CHAPTER 1

INTRODUCTION

1.1 History and Purpose of this Analysis

Figure 1-1. The four tests for Type B casks

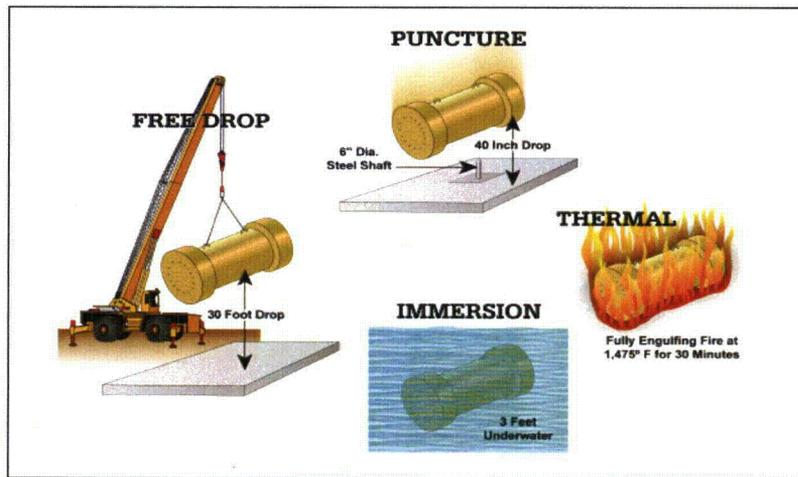
Comment [MF20]: If possible make the puncture test pin taller. It appears the impact limiters will impact the ground before the cask body impacts the puncture pin. Also number the tests to show sequence (1-drop, 2-puncture, 3-thermal, 4-immersion).

Figure 1-2. NAC-STC cask (courtesy of NAC International)

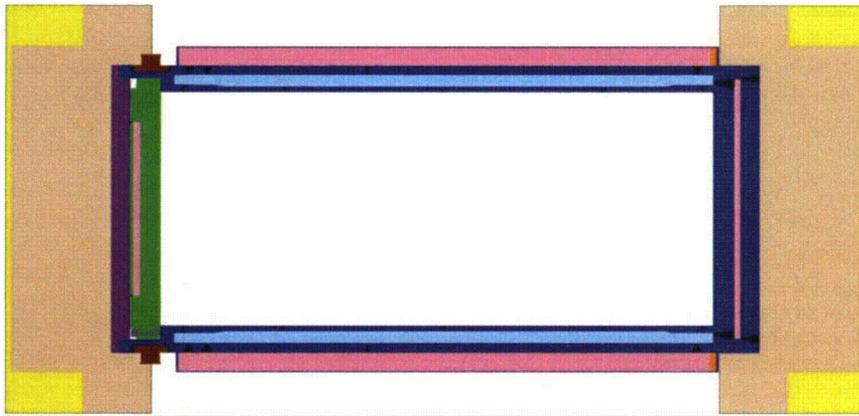
Comment [h28]: EDITORIAL: If this graphic is included it should be annotated to identify the relevant features. If not, it is more confusing than helpful.

Figure 1-3. Basic layout of the HI-STAR 100 rail transport cask (from Haire and Swaney, 2005, and Holtec International, 2004)

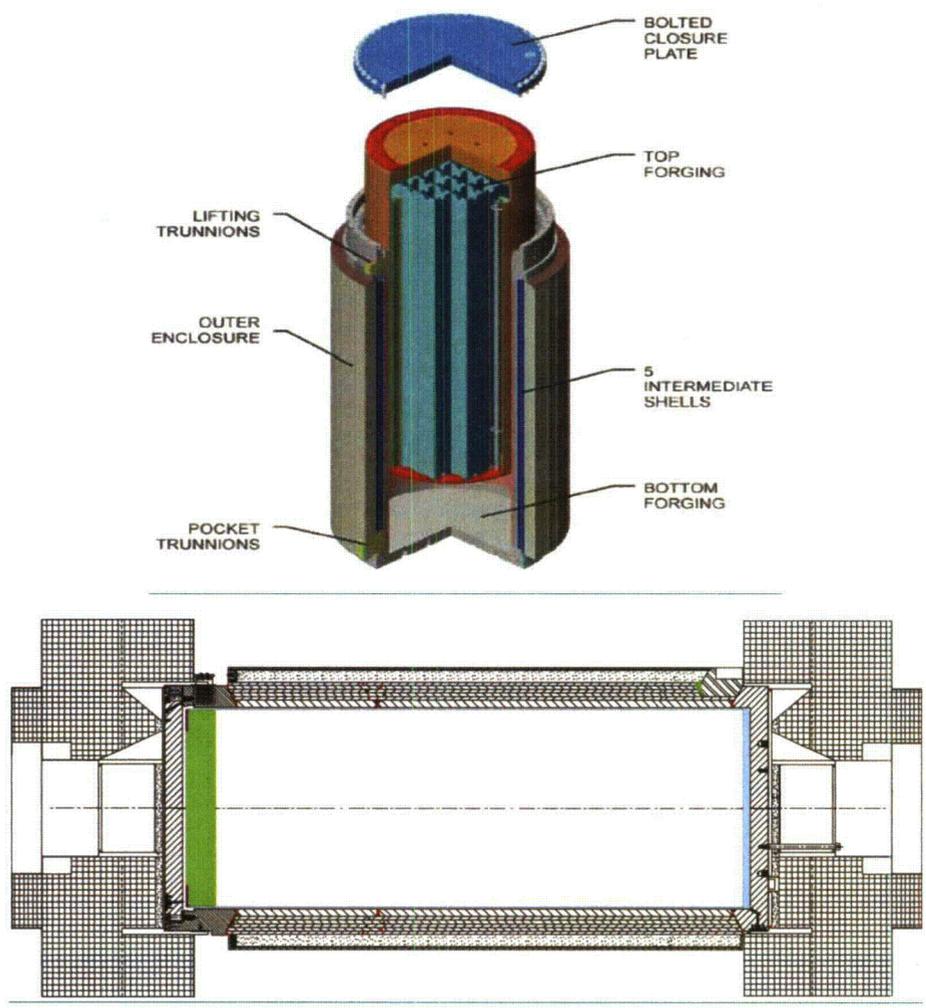
Comment [h29]: EDITORIAL: Again this would be far more useful if major components were annotated on this graphic. What does the green bar represent?
